Technical Service Bulletin Notification TSB #16-040

Jayco has determined that certain Model Year 2017 White Hawk Travel Trailers require the Sanicon motor circuit removed from the 20 amp circuit breaker and added to the 30 amp circuit breaker.

TSB#: 16-040 Job Code: 9801336 Flat Rate: .5 hr

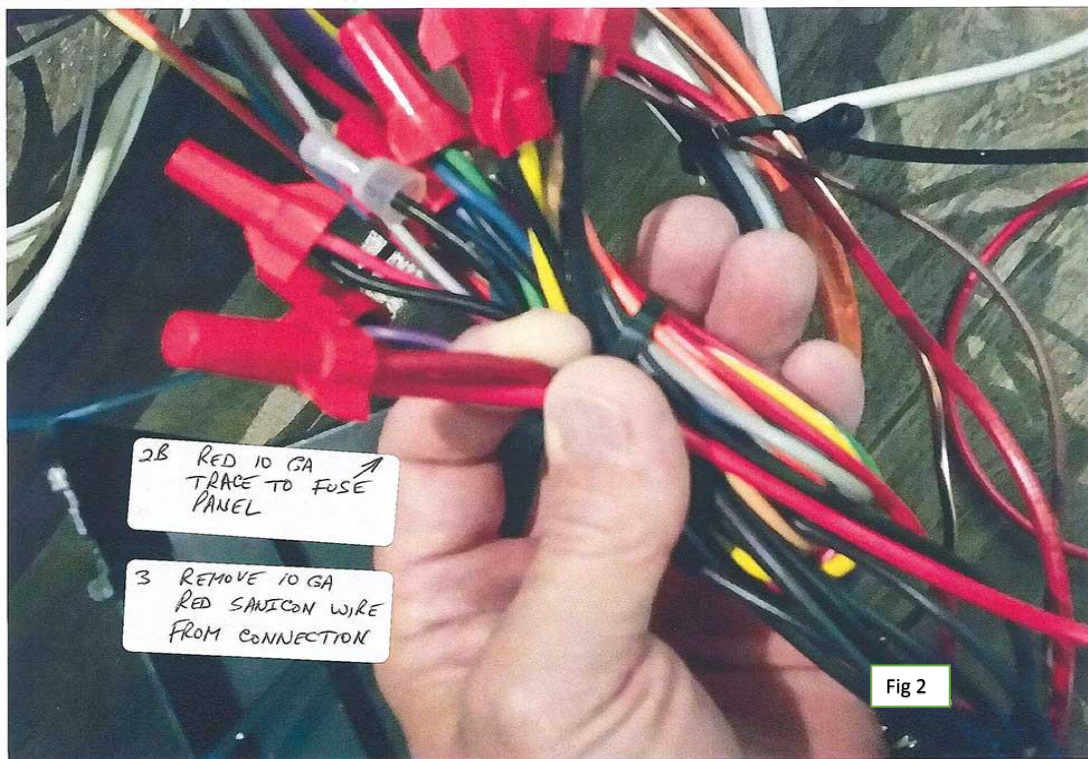
- 2 **Fig 1:** Locate 12-volt output wire from "Main Slideout" fuse (Fuse #2 for 30-amp shore power, Fuse #17 for 50-amp shore power) on back side of 12-volt fuse panel.
- 3 **Fig 1:** Locate 30-amp Sanicon Circuit breaker attached to floor inside power converter/load center/12-volt fuse panel. Remove circuit breaker from floor of panel.

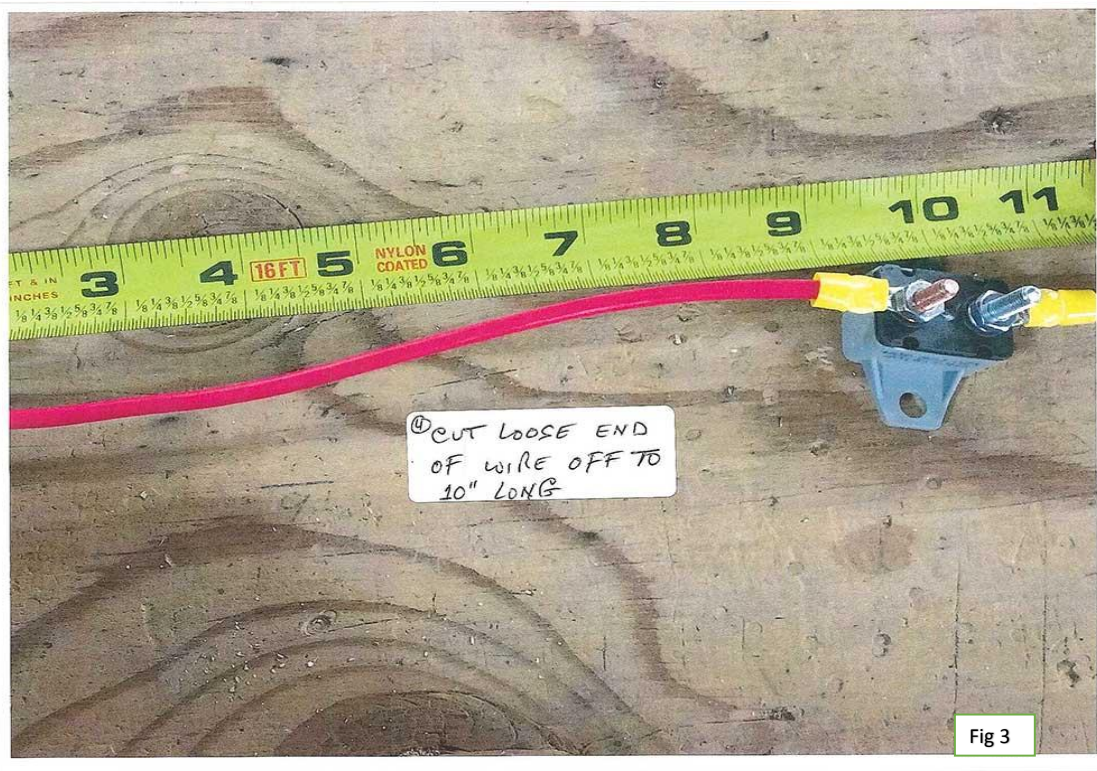
4 **Fig 2:** Disconnect red colored wire powering Sanicon circuit breaker from "Main Slideout" output wire at back side of power converter/load center/12-volt fuse panel.

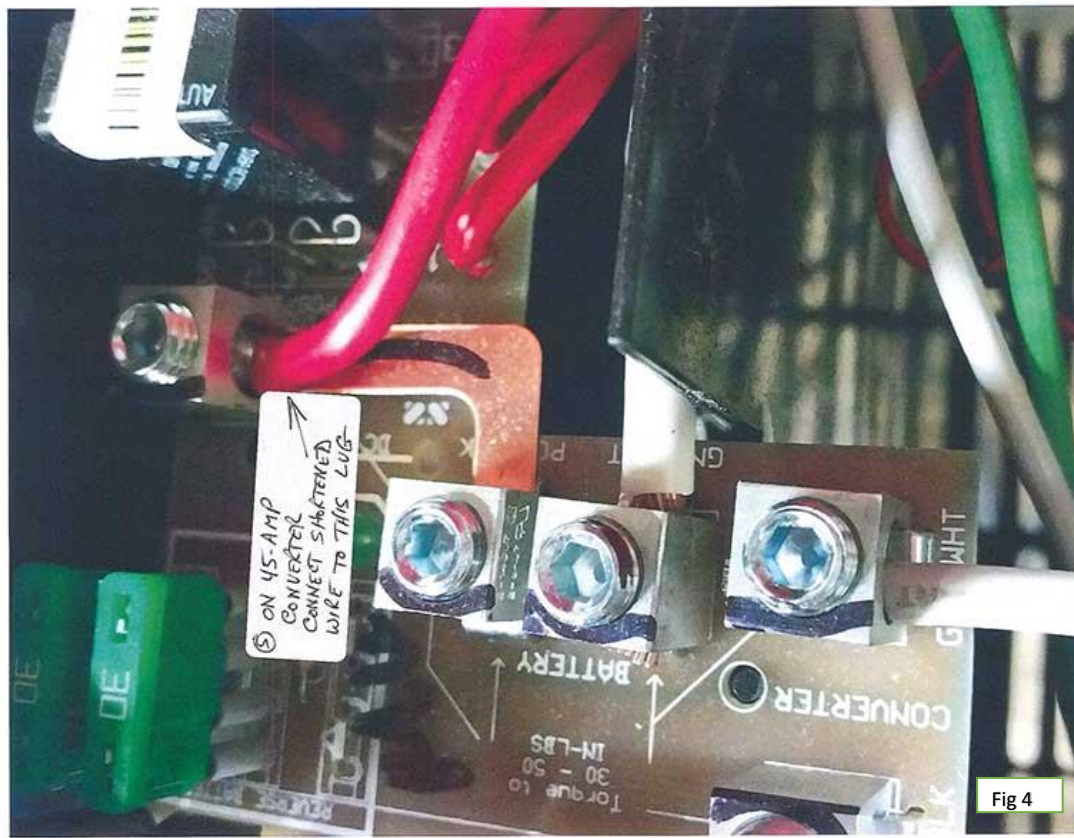
Fig 3: Cut wire back 10" from circuit breaker. Strip off 5/16" of wire insulation.

Fig 4

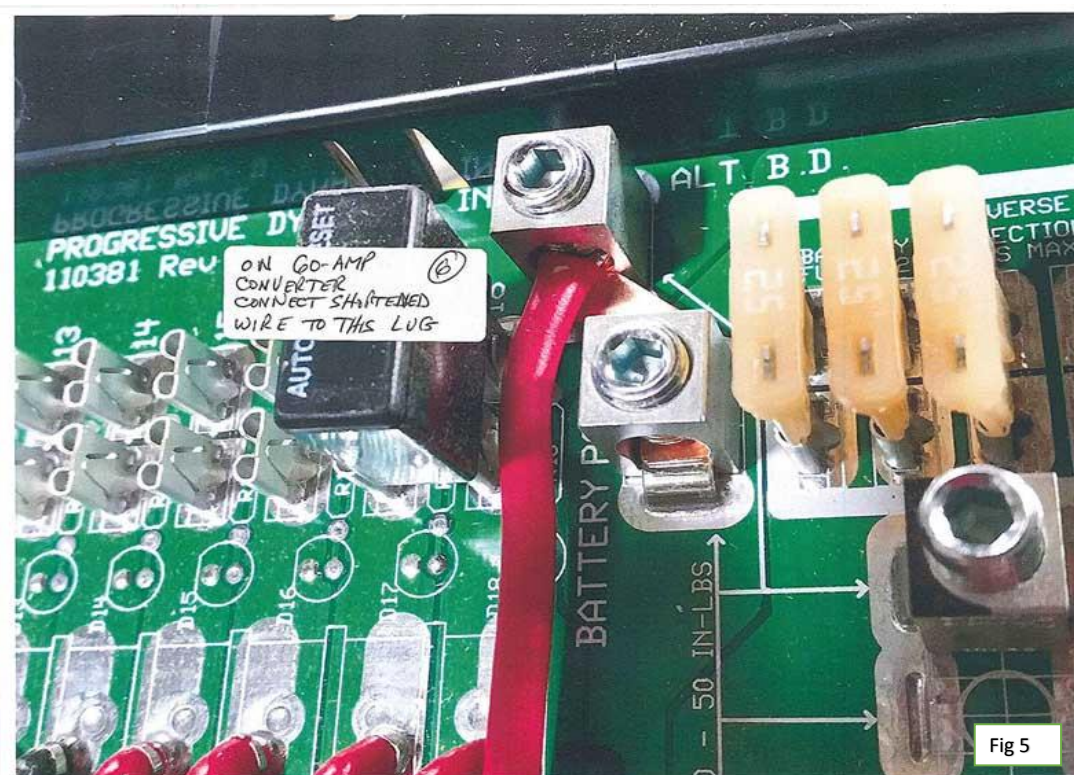
5 Fig 4: Insert loose end of red colored wire through open cavity in rear of 12-volt fuse cavity.

Fig 5

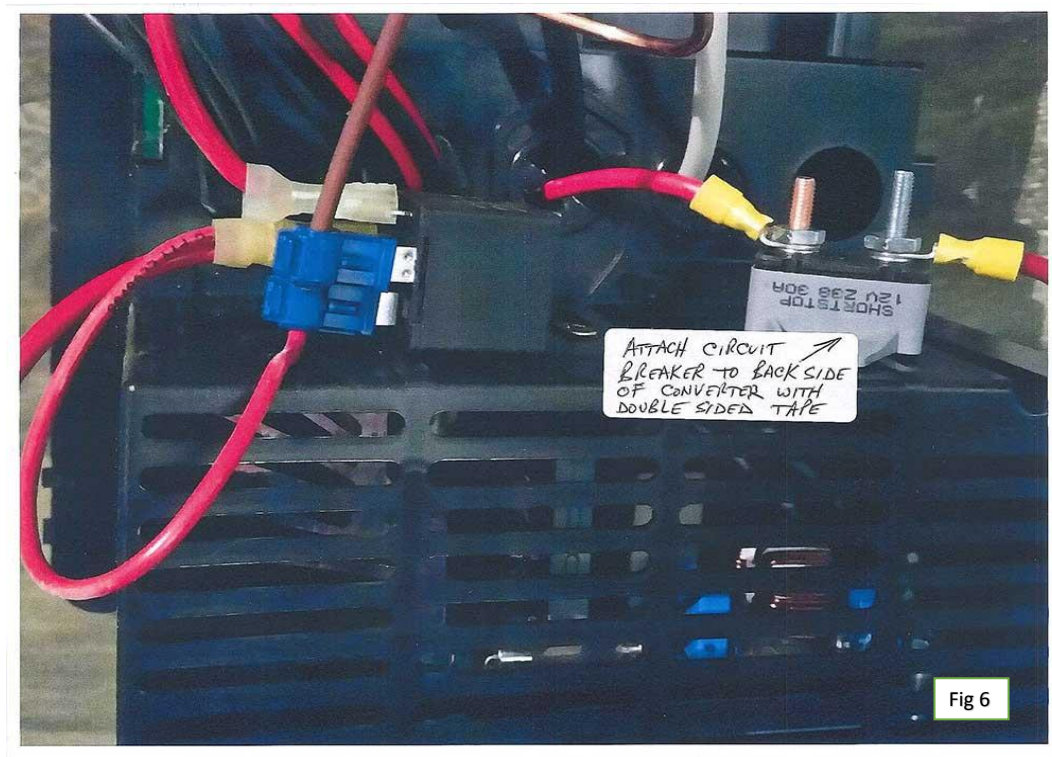
6 Fig 5: Attach loose end of red colored wired to fuse panel buss bar as shown in photos.
